Coronado
> Business Class M2
Cascadia
108SD/114SD

Freightliner
Service Bulletin

Some M2 vehicles with Allison 6-speed transmissions may produce a buzzing or chirping noise emanating from the shift lever. This usually happens when the transmission is in 6th gear, and the vehicle is moving at 50 to 55 mph (80 to 89 kph). Shifting out of 6th gear stops the noise. A shift cable isolator kit has been developed to eliminate the cause of the noise. If a noise is emanating from the shift lever or shift cable, use the procedure in this bulletin to replace the existing shift cable clamp on the transmission with the isolator kit KPP 294201.

Fig. 1, Existing Shift Cable Installation

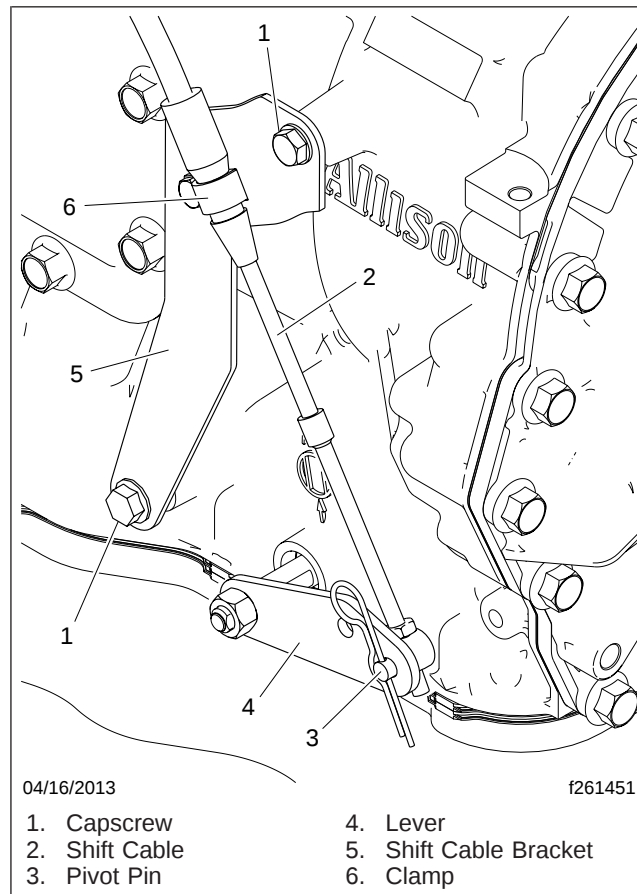
1. Park the vehicle on a level surface, set the transmission in NEUTRAL, shut down the engine, and set the parking brake. Chock the tires.
2. Remove the cotter pin, then remove the pivot pin and shift cable from the transmission shift lever. See [Fig. 1](#).

3. Remove the pivot pin from the shift cable.
4. Remove the clamp that secures the shift cable to the cable bracket. Save the bolt and discard the clamp.

Fig. 2, Isolator Kit KPP 294201

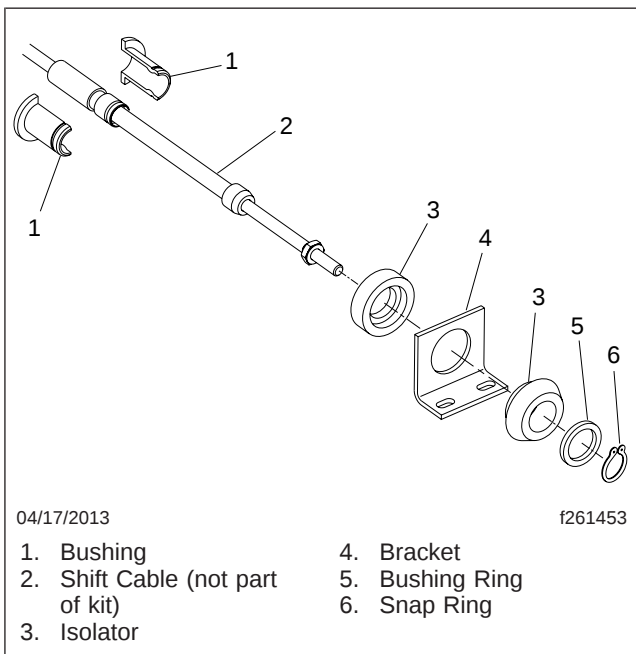
5. Remove the two capscrews that attach the cable bracket to the transmission, then remove the bracket.
6. Using the isolator kit mounting bracket (**Fig. 2**, item 4) as a template, with one hole positioned over the existing hole in the cable bracket, mark and drill a 1/4-inch (7-mm) hole in the cable bracket, as shown in **Fig. 3**.
7. Enlarge the existing holes in the isolator kit mounting bracket to fit the fasteners.
8. Install the new bracket on the shift cable bracket, using the existing capscrew and the new bolt, nut, and washers. See **Fig. 4**. Tighten the existing capscrew 35 lbf-in (395 N-cm), and the new bolt 60 to 84 lbf-in (680 to 950 N-cm).

Fig. 5, Snap Ring Installation

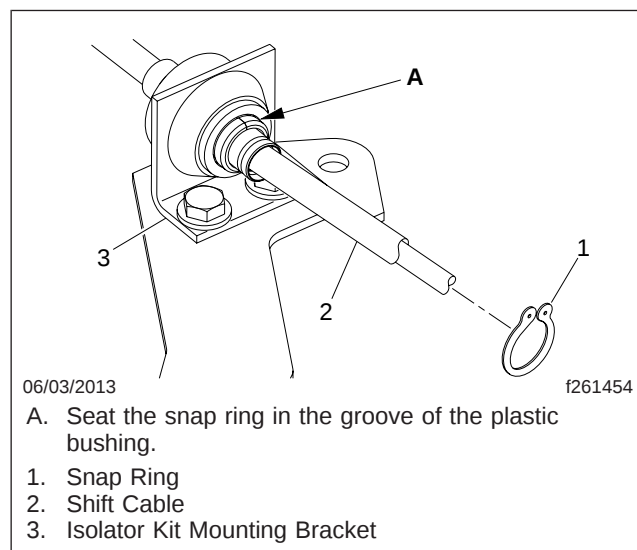
9. Install the cable in the bracket using the remaining isolator kit parts. Make sure the snap ring is seated in the groove of the plastic bushing; see **Fig. 5**.

Fig. 6, Isolator Kit Installed

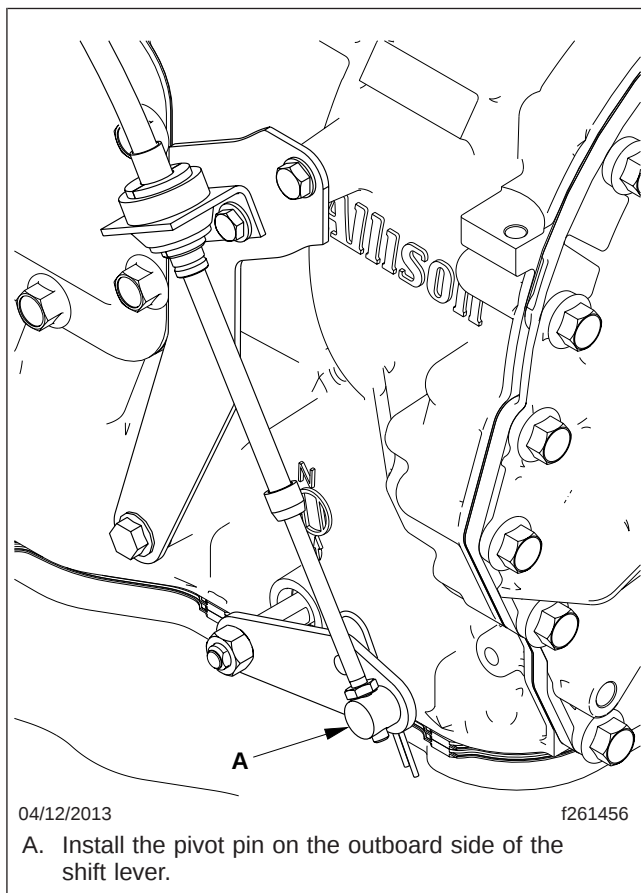
10. Install the pivot pin on the shift cable.
11. Install the cable bracket on the transmission. Tighten the capscrews 18 to 21 lbf-ft (24 to 28 N-m).
12. Install the pivot pin on the outboard side of the shift lever, as shown in **Fig. 6**.

Fig. 7, Neutral Position Indicator

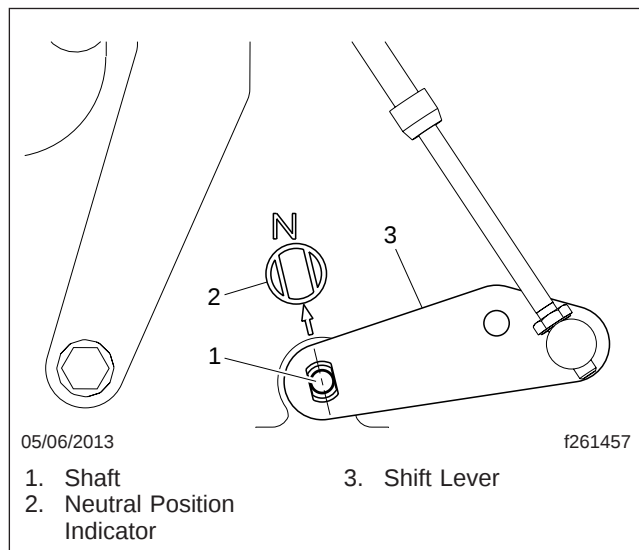
13. Make sure the shift control on the dash is set to "Neutral", and the shift lever on the transmission is in the "Neutral" position, as determined by the orientation of the shift lever shaft and the neutral position indicator. See **Fig. 7**.
